Product Change Notice (PCN)

Subject: Addition of a production site and material changes for RH850/F1KM-S2, S4 and F1KH-D8 Series

PCN#: [HPLM-2025-0182]
PC-MCU-A044A/E

ATJ-Kumamoto LQFP Mark Example: R7F7017643AFD-C#BA1 (F1KM-S2 176pin)

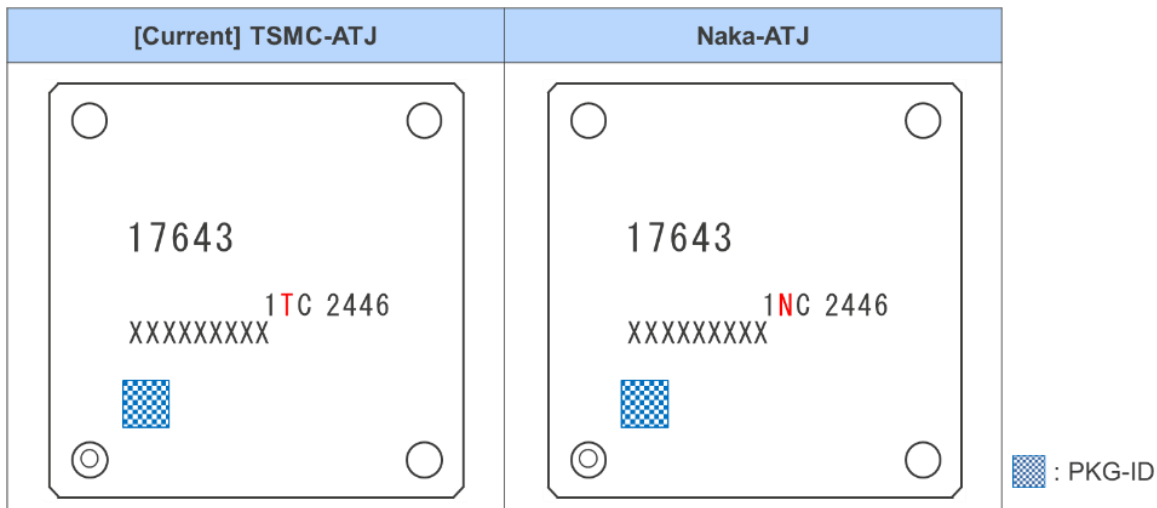
The red character is different between TSMC and Naka products (TSMC: T, Naka: N).

Suzhou LQFP Mark Example: R7F7017643AFP-C#BA1 (F1KM-S2 176pin)

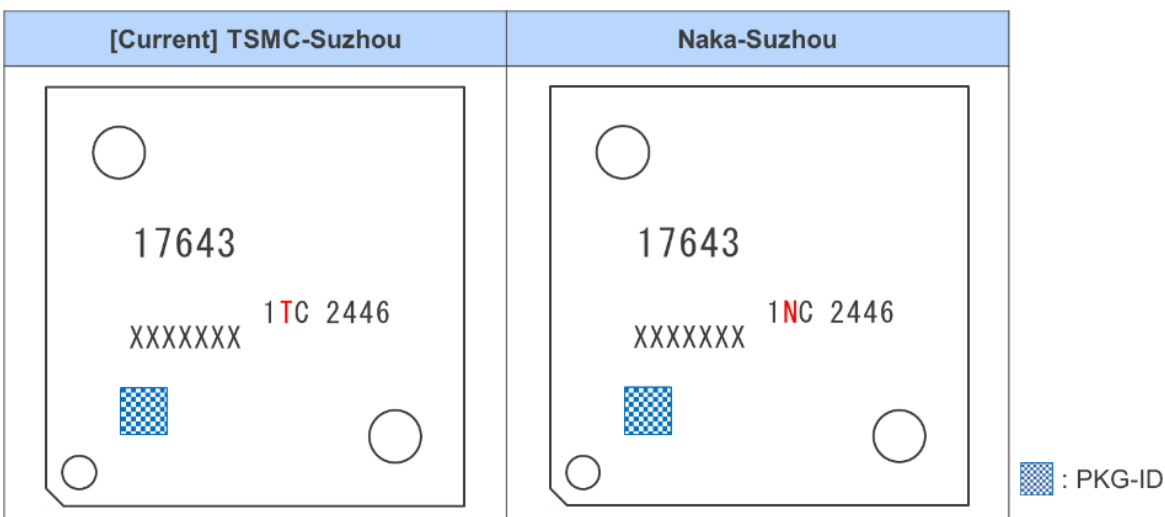
The red character is different between TSMC and Naka products (TSMC: T, Naka: N).

Yonezawa BGA Mark Example: R7F7016534ABG-C#BC1 (F1KM-S4 272pin)

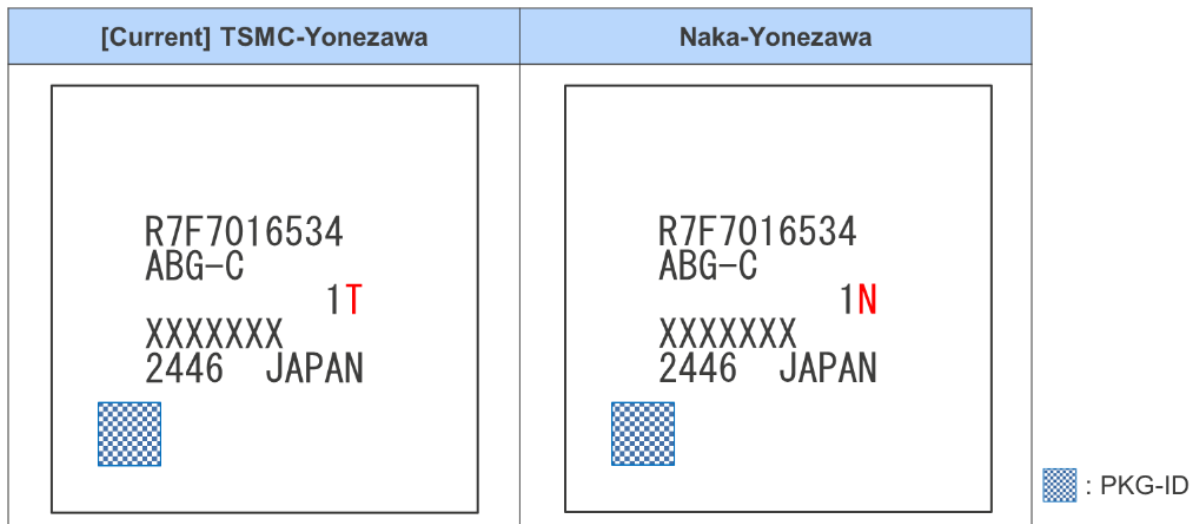
The red character is different between TSMC and Naka products (TSMC: T, Naka: N).
